**GROUNDWATER REPORT  
OAK PRAIRIE**

**NW1/4 Sec. 19 - T. 10N., R. 5E.  
NW 140<sup>th</sup> & West Holdrege Road**

**December 9, 2003**

**DATE:** December 16, 2003  
**TO:** Mike DeKalb  
Planning Department  
**FROM:** Larry V. Worrell  
County Surveyor  
**SUBJECT:** OAK PRAIRIE PRELIMINARY PLAT AND CUP

Figure 1. Oak Prairie, N.W. 140th and West Holdrege Street, Community Unit Site Plan.

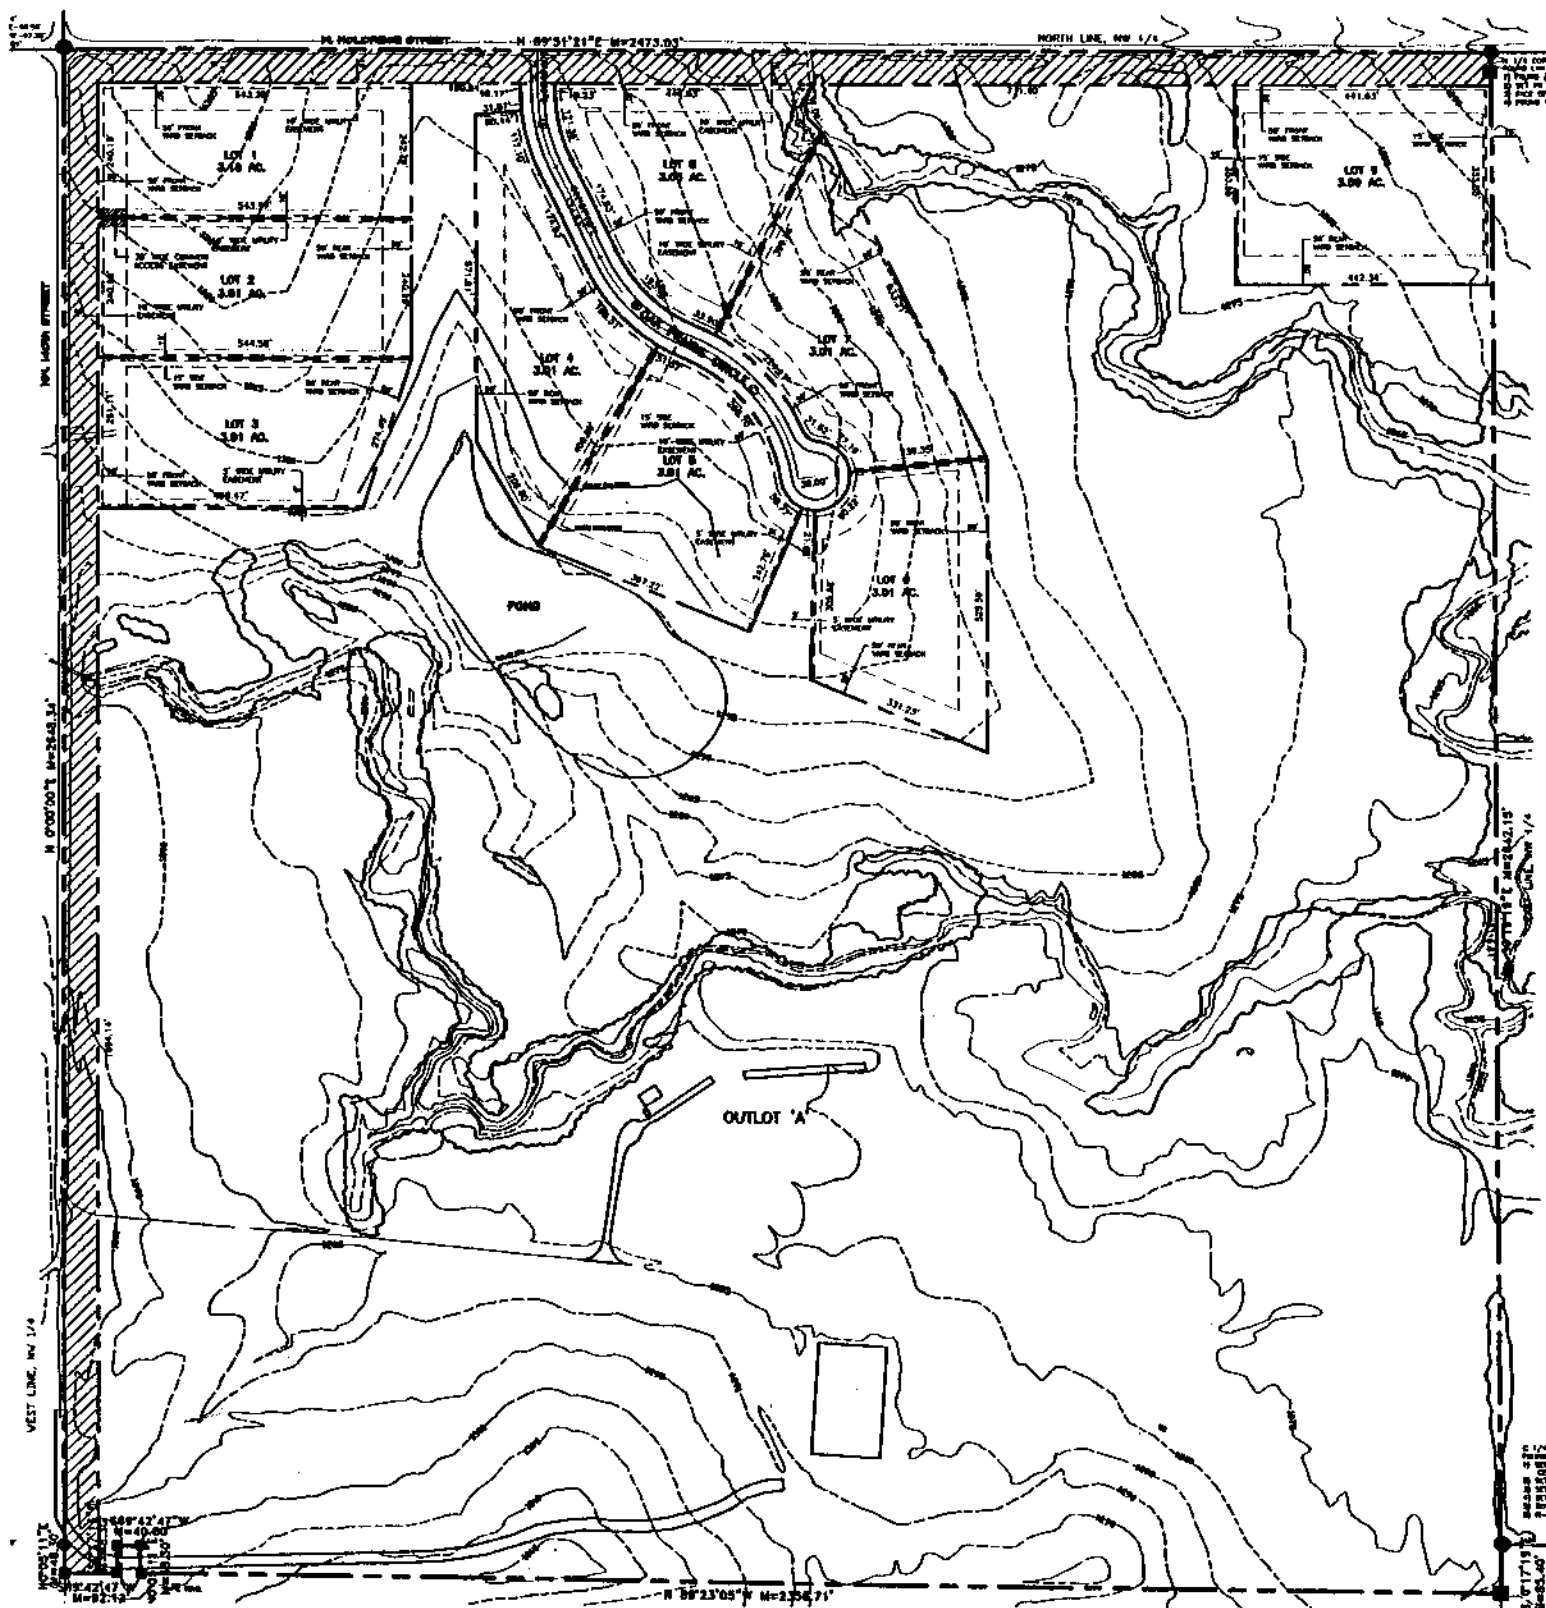
- 1) Dedication of 60 feet of right-of-way along West Holdrege Street and NW 140<sup>th</sup> Street shall be shown.
- 2) As per *Note 7*, Oak Prairie Circle shall be constructed and surfaced to Lancaster County standards.

- 3) The lot layout shall be modified to provide access to all lots from interior streets.
- 4) As per *Note 19*, all lots are permitted only one residential access.

- 5) As per *Note 8*, the developer shall be responsible for all signs required.
- 6) Additional information should be provided on the pond expansion and how the pond design relates to the residential lots.

- 7) The 100 year FEMA floodplain does not match the land contours. Additional hydrological or grade studies shall be submitted to determine minimum building elevations for Lots 7, 8 and 9.

- 8) Culvert design and drainage area information is needed for the culvert under Oak Prairie Circle.
- 9) The existing profile of West Holdrege Street is not accurate and should be field verified.

- 10) *Note 11* refers to an existing farm access on West Holdrege Street that is not shown.
